AWGN Noise models for PHY Evaluation

GEORGE ZIMMERMAN, CME CONSULTING

2/8/2024 – UPDATED AND CORRECTED AFTER PRESENTATION AT
2/7/2024 AD HOC

100BASE-T1L PSANEXT only
(equal length, long line)

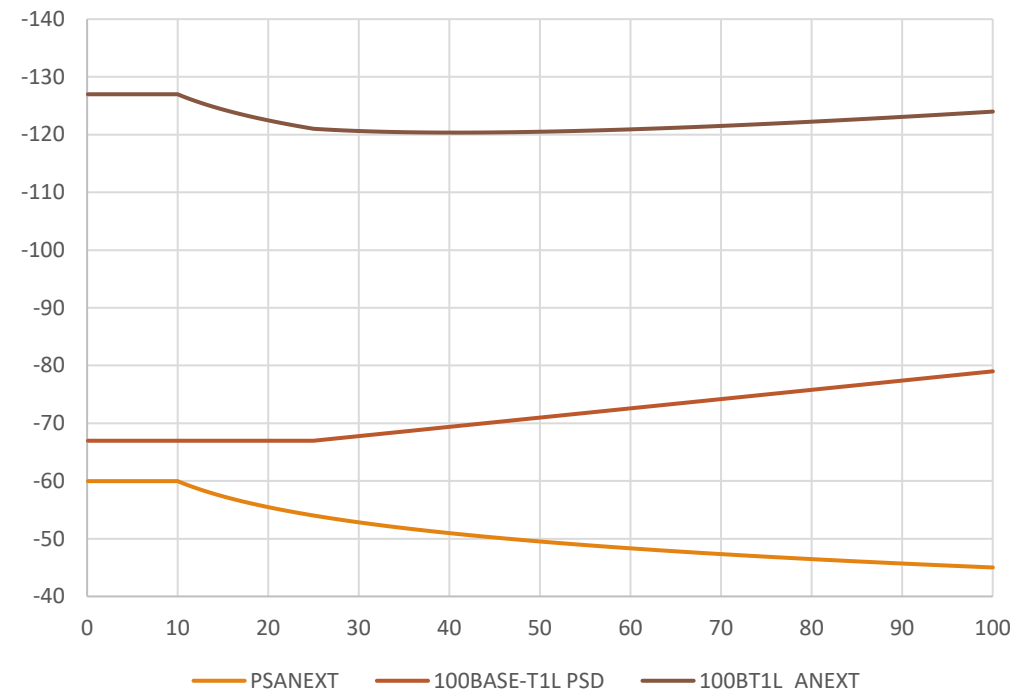
Error – 60 MHz wideband average is higher, not lower,
Clarified – linear average, not geometric (db)

Recommend for this case, AWGN:

$-122.7 \text{ dBm/Hz} - 10\log_{10}(f_{\text{baud}}/75) \text{ dBm/Hz}$

Mixed Crosstalk / Near-far “fixed” for 100BASE-T1L (100BASE-TL ANEXT dominates)

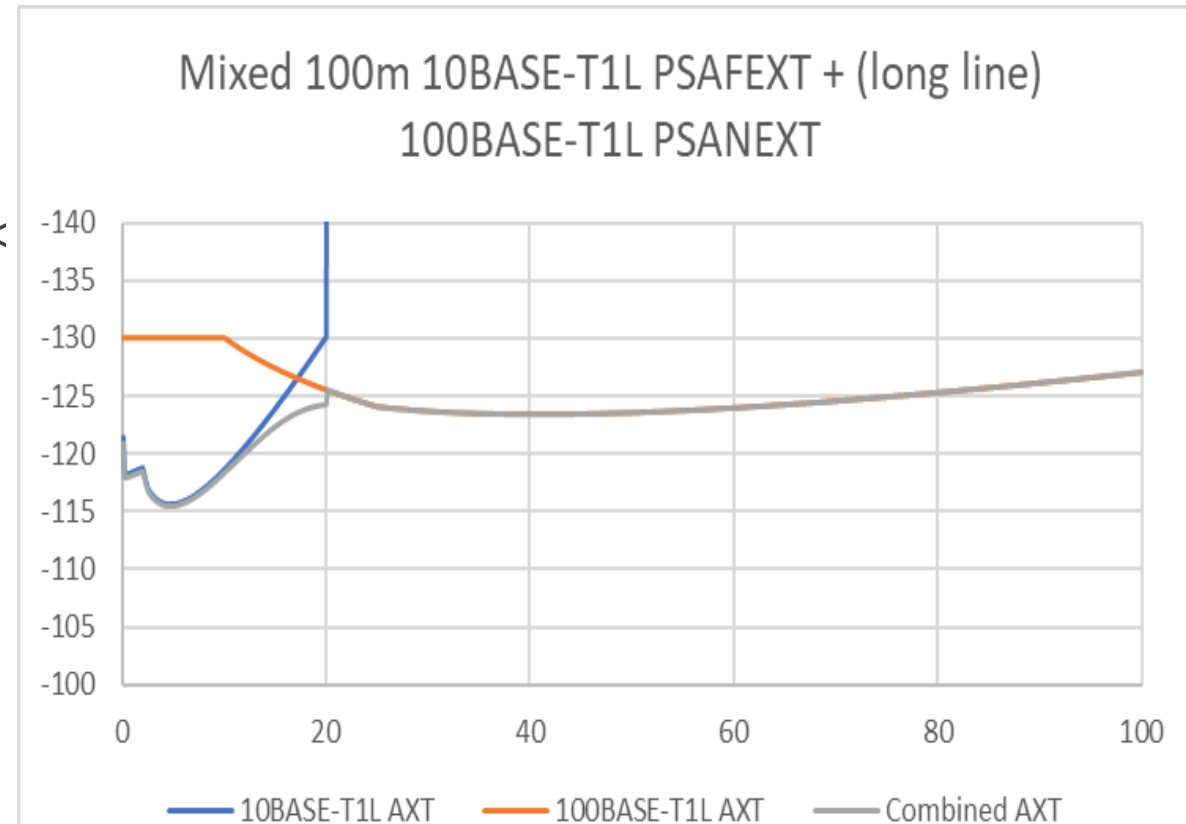
Slide title corrected, levels adjusted based on average measurements for 0-5Mhz, 5Mhz-37.5MHz linear po
for source 1 is -121.2 (1.3 dB higher), source 2 -116.8 (0.2 dB higher)

Recommend for this case, Sum of 2 AWGN sources

Source 1:

-121.2 dBm/Hz – $10\log_{10}(f_{\text{baud}}/75)$ dBm/Hz

Source 2:

-116.8 dBm/Hz 0 to 20 Mhz, filtered by 2nd order LPF at 5 MHz

10/100 Mixed Crosstalk

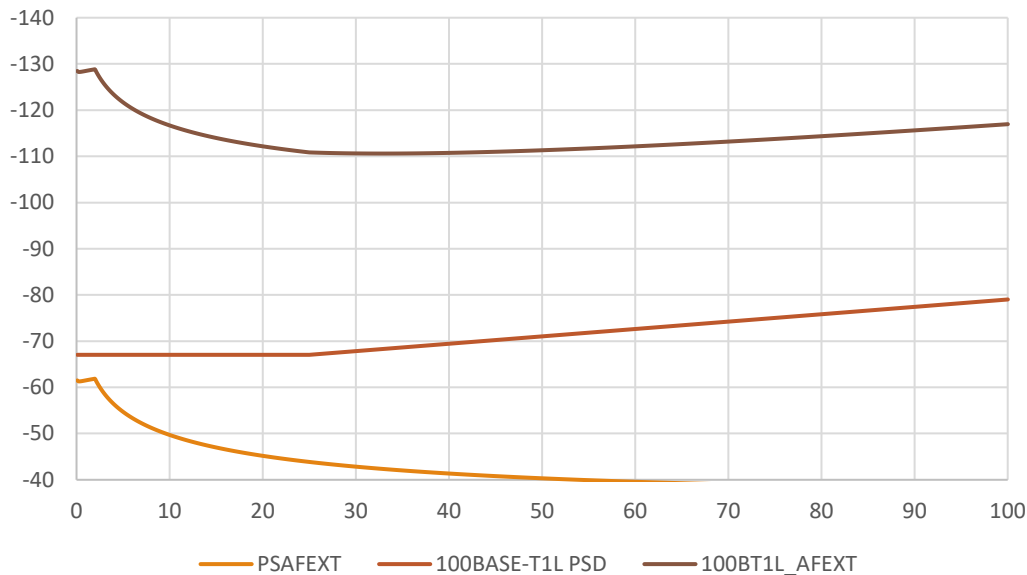
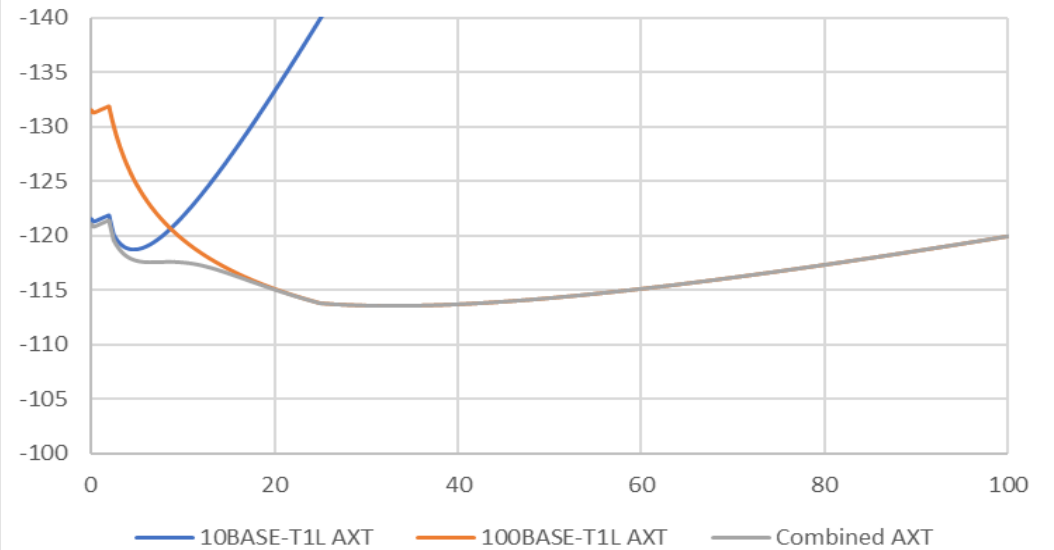
FIXED TO SHOW CORRECT WORST CASE – 100BASE-T1L FEXT AND LEVELS FIXED
previous slide showed right hand case only

Use $-112.9 - 10\log_{10}(f_{\text{baud}}/75)$ dBm/Hz AWGN source

Use combined -116.7 dBm/Hz 5MHz 2nd order filtered plus -115.0 dBm/Hz- $10\log_{10}(f_{\text{baud}}/75)$ dBm/Hz source
OR use -115.4 dBm/Hz $-10\log_{10}(f_{\text{baud}}/75)$ AWGN source
